**WARRANTY
BULLETIN**

Wb01-02

DATE : MARCH 2001	SECTION : 16 – SUSPENSION
EXPIRATION: MARCH 2002	
SUBJECT : PROTECTIVE PANELS FOR THE HEIGHT CONTROL VALVE

FIGURE 1: POTECTIVE PANNEL INSTALLED (SAME ON BOTH SIDES)

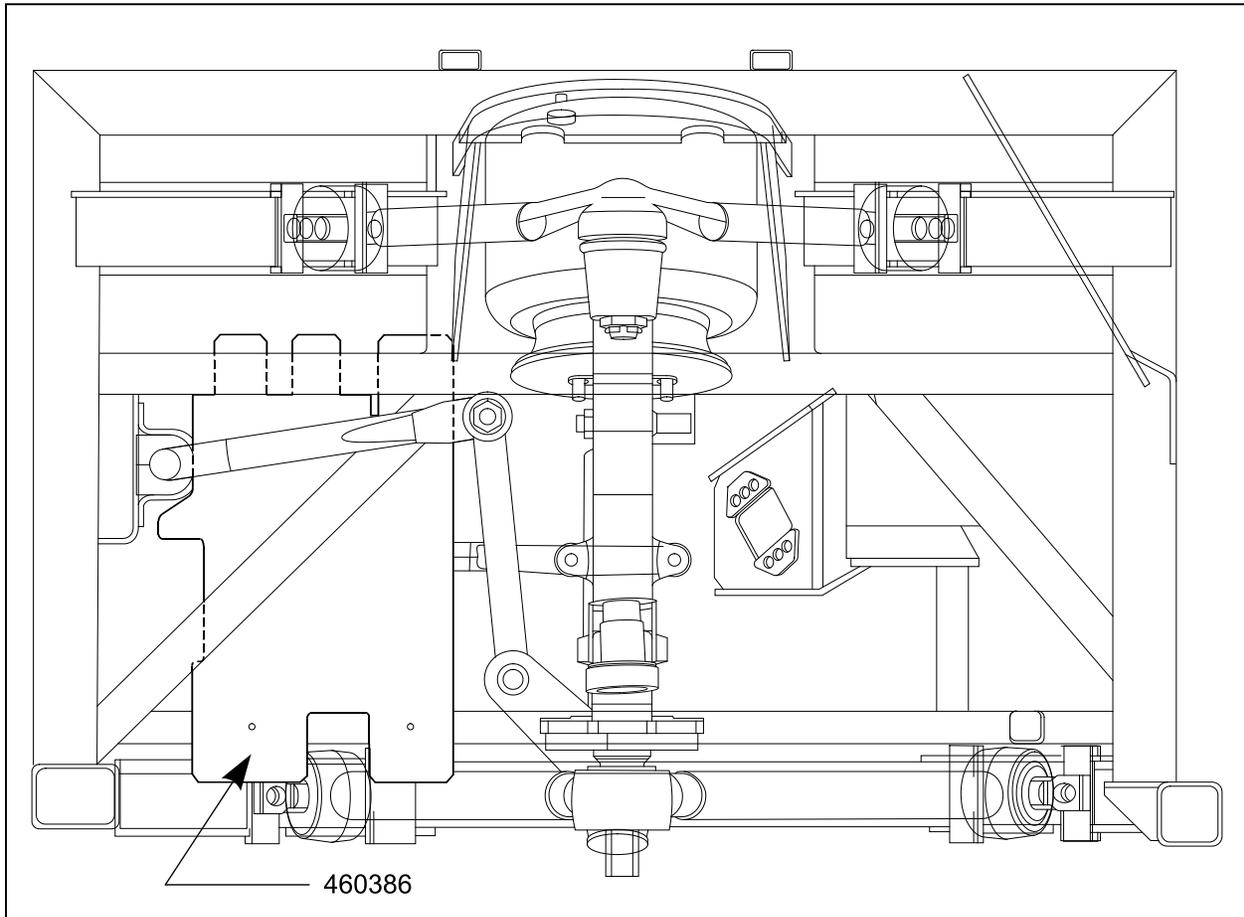
On the above-mentioned coaches, two protective panels designed to prevent ice build-up on the height control valve may be missing. Follow the instructions below to install the panels.

2. Find the height control valve for the front suspension;
3. Install the panels (one per side) and secure using the screws included (refer to figure 1).
